November 17, 2025
Subject: Pleasant Avenue Crossing
Bridge Wearing Surface
Replacement
State WIN: 023120.00
Location: **Dover Foxcroft**
Amendment No. 4

Please make the following changes to the Bid Documents:

SHEET NUMBER
59
OF 64

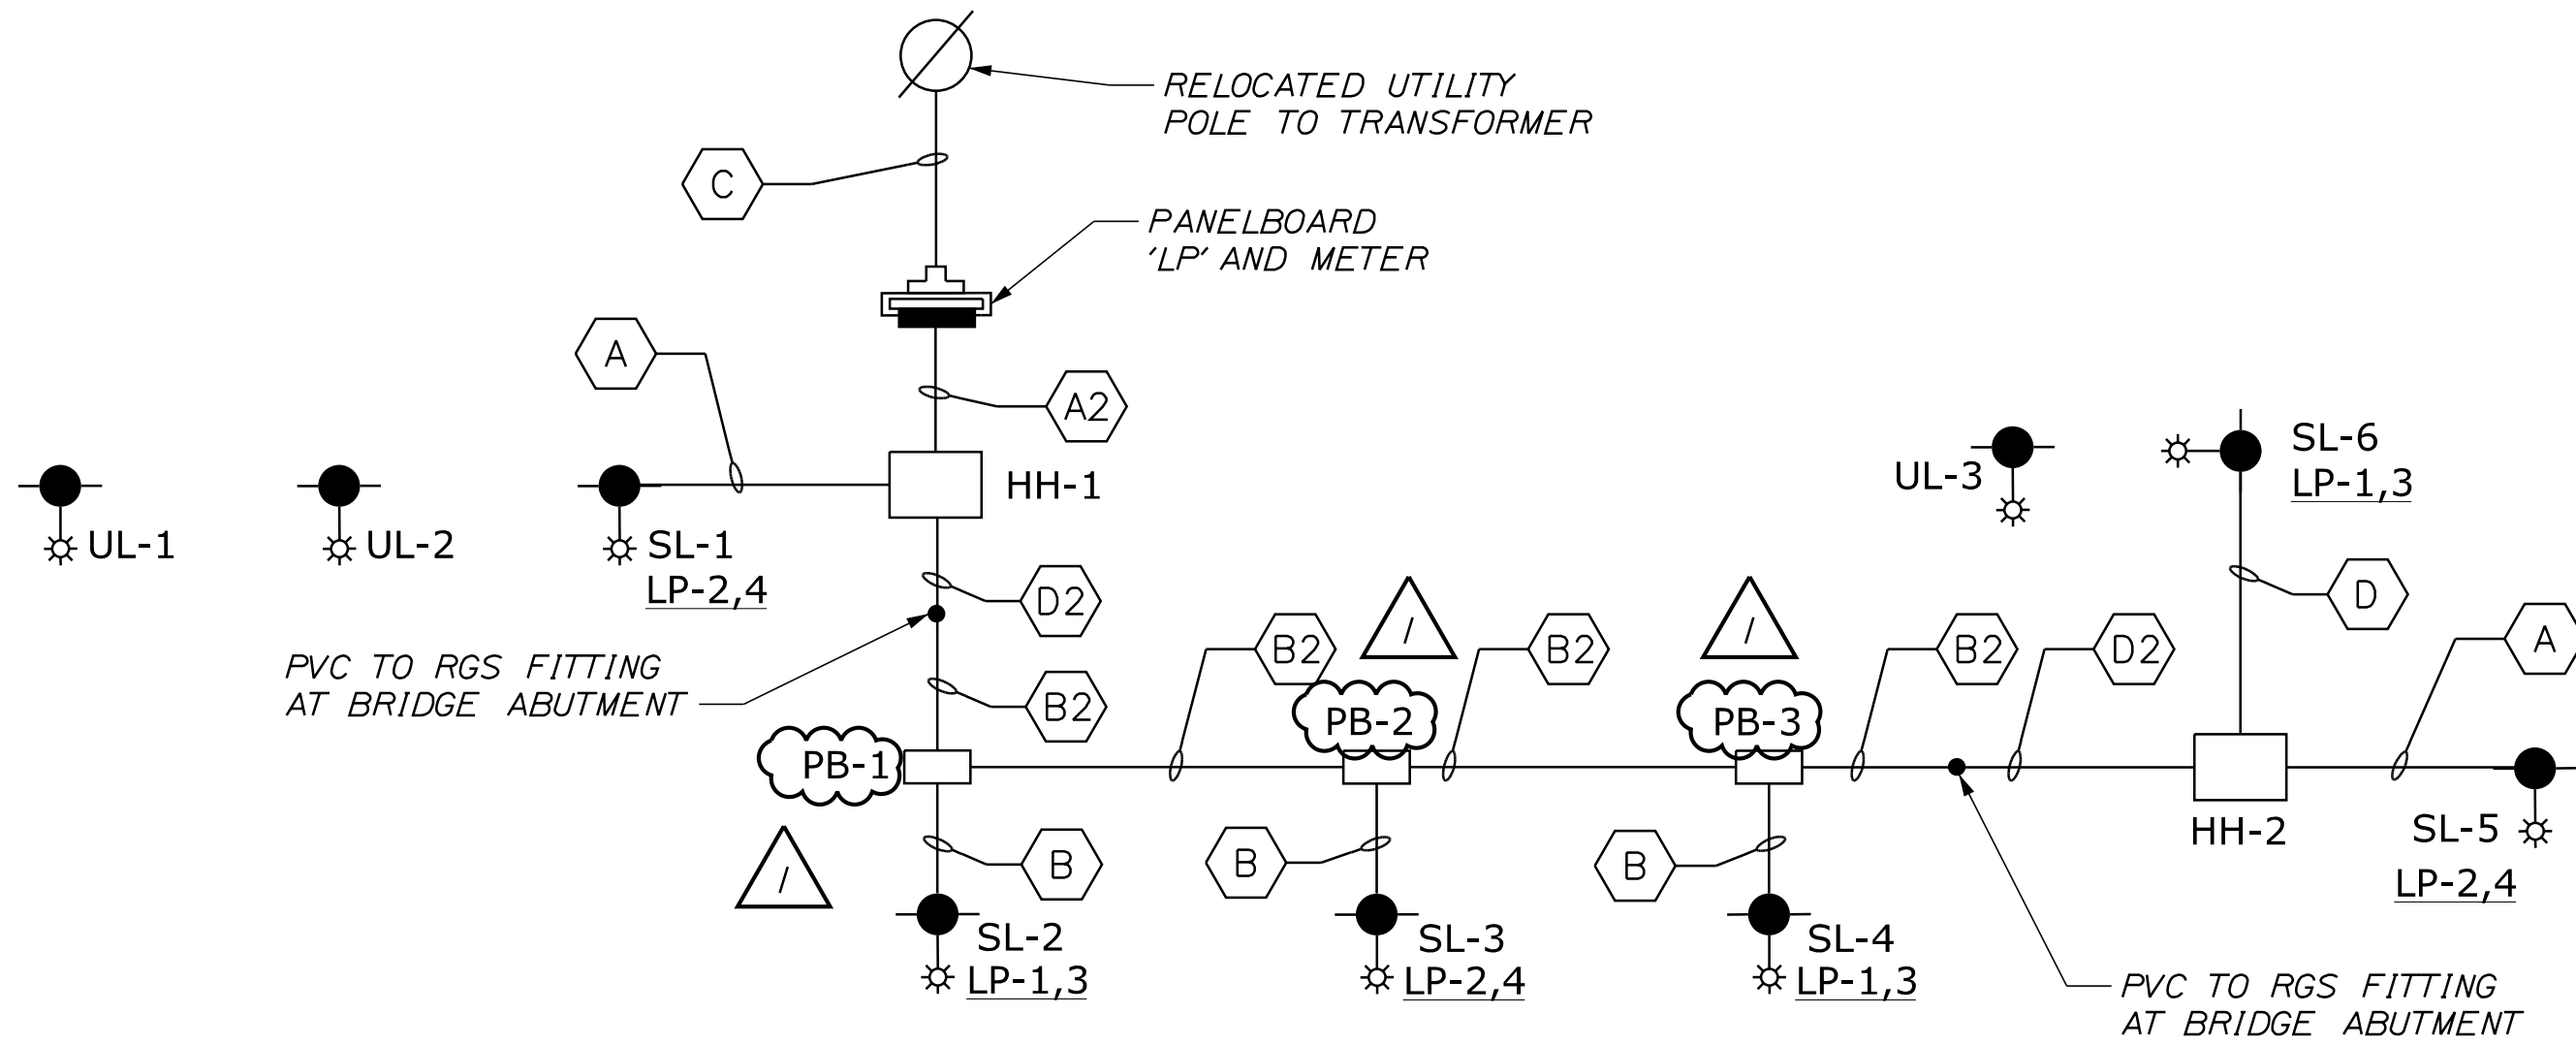
Question: Sheet 59, Note 2 states that the “New power service, control cabinets, meter disconnects, and enclosures will be paid for under Item 634.160 Highway Lighting” What is Item no. 634.25 used for?

Question: The details on page 55 in the plans states that the lighting conduit will be 2 inch, the conduit schedule on page 59 states that lighting conduit is 3 inch, which one is correct? Will the conduit be supported under the bridge or will the conduit be installed in the bridge deck?

Response: Item 634.25 Service Pole Complete with Cabinet and Controller is not needed and has been removed from the estimate. Please refer to the updated “Proposal Schedule of Items” and the updated ESTIMATED QUANTITIES sheet.

Response: The lighting conduit size noted on sheets 47 and 55 has been changed from 2” diameter to 3” diameter. Please reference the revised sheets 47 and 55. The conduit will be supported under the bridge by Utility Support Type T2 as indicated on sheet 47. Type T2 support shall be installed between G4 and G5 as shown on the framing plan on sheet 45.
